## PŘÍKAZ K ZACHOVÁNÍ LETOVÉ ZPŮSOBILOSTI

**Číslo: FAA AD 2011-06-05**

**[Docket No. FAA-2009-1253; Directorate Identifier 2009-NM-080-AD; Amendment 39-16629; AD 2011-06-05]**

#### **Airworthiness Directives; The Boeing Company Model 737-600, -700, -700C, -800, -900, and -900ER Series Airplanes**

**Figure 1**

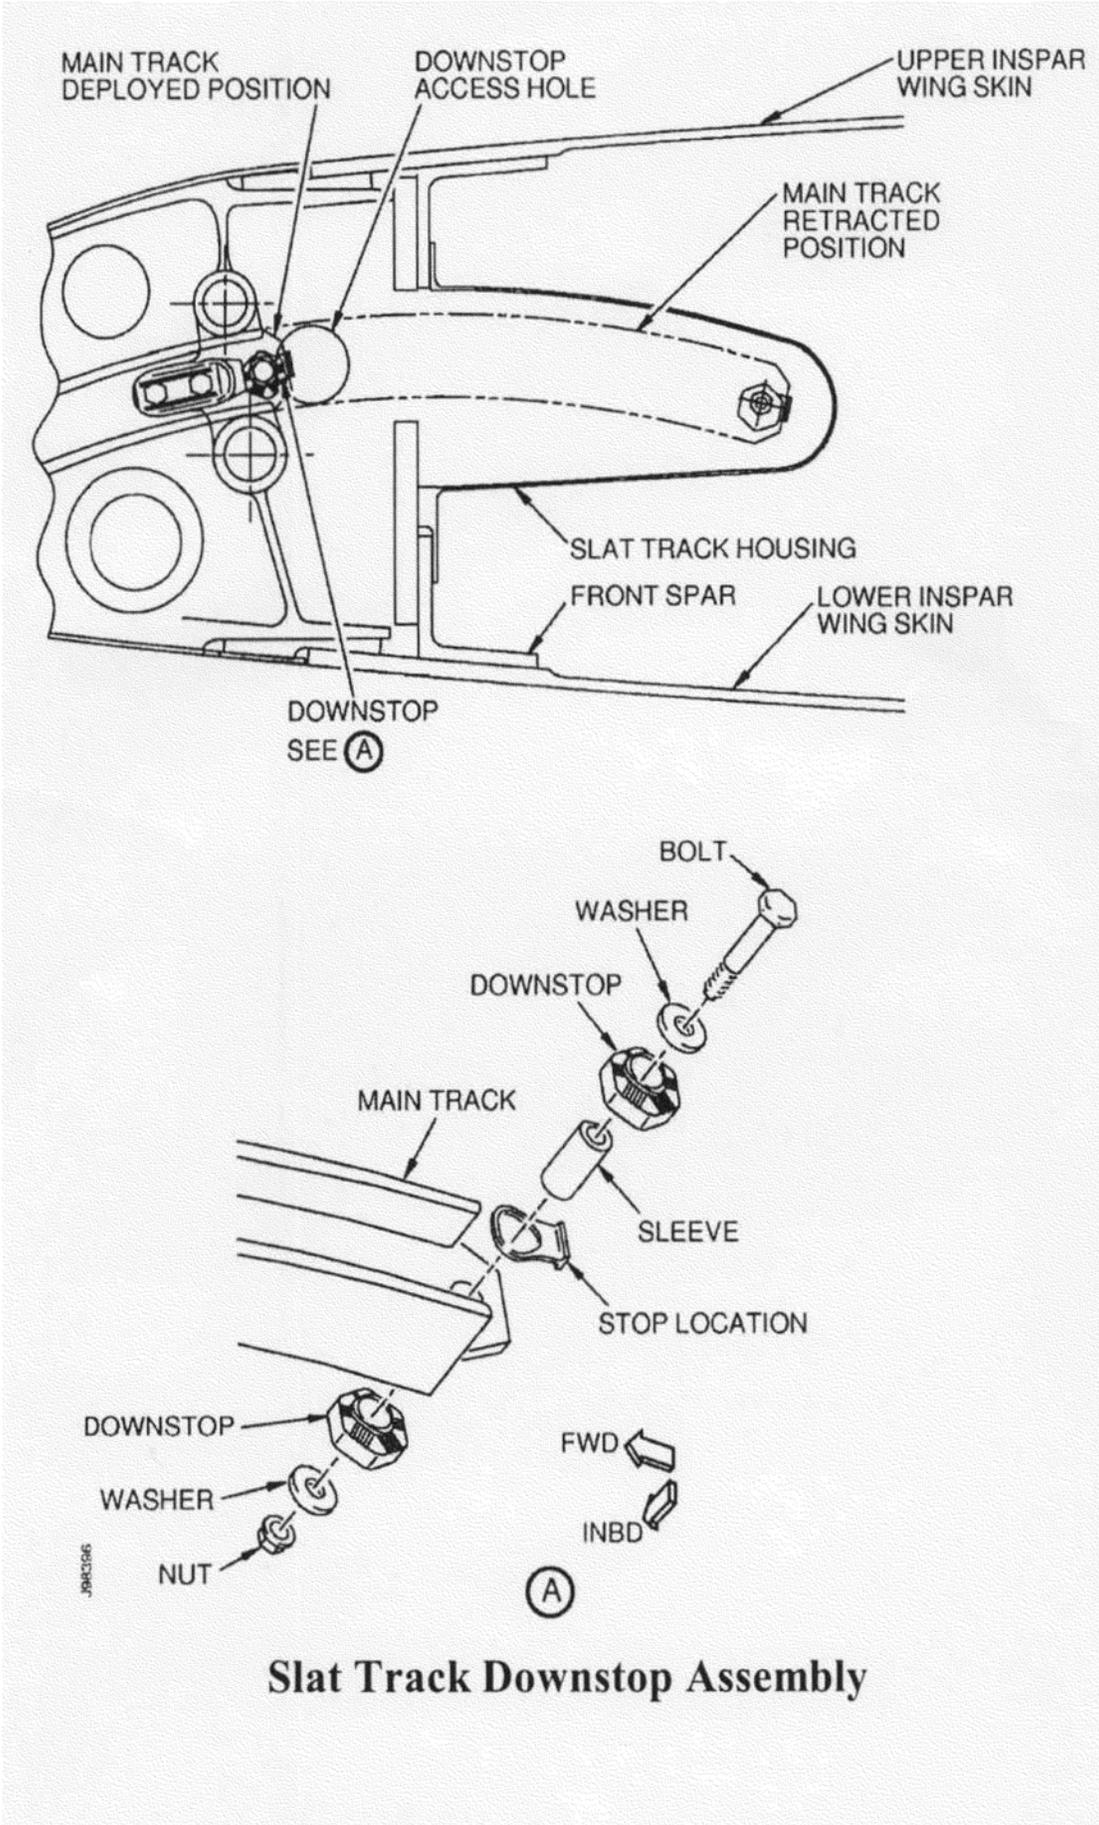
(g) Within 10 days after September 26, 2007 (the effective date of AD 2007-18-52): Do a detailed inspection or a borescope inspection of each main slat track downstop assembly to verify

proper installation of the slat track hardware (i.e., the bolt, washers, downstops, stop location, and nut shown in Figure 1 of Boeing Service Letter 737-SL-57-084-B, dated July 10, 2007, and in this AD). Proper installation of the sleeve need not be confirmed, and the stop location part may be installed on either the inboard or the outboard side of the slat track. If any part is missing or is installed improperly, before further flight, install a new or serviceable part using a method approved in accordance with the procedures specified in paragraph (j) of this AD; and do a detailed inspection of the inside of the slat can for foreign object debris (FOD) and damage. Before further flight, remove any FOD found and repair any damage found using a method approved in accordance with the procedures specified in paragraph (j) of this AD. Verify proper installation; install a new or serviceable part; and inspect for damage and FOD, and remove FOD and repair damage; in accordance with a method by approved by the Manager, Seattle Aircraft Certification Office, FAA; or in accordance with Boeing Multi Operator Message Number 1-523812011-1, issued August 25, 2007, or 1-527463441-1, issued August 28, 2007. Repeat the actions required by paragraph (g) of this AD thereafter at intervals not to exceed 3,000 flight cycles.

(h) Within 24 days after receipt of emergency AD 2007-18-51: Apply a torque between 50 to 80 inch-pounds to the nut. The bolt head must be held with the torque applied to the nut.
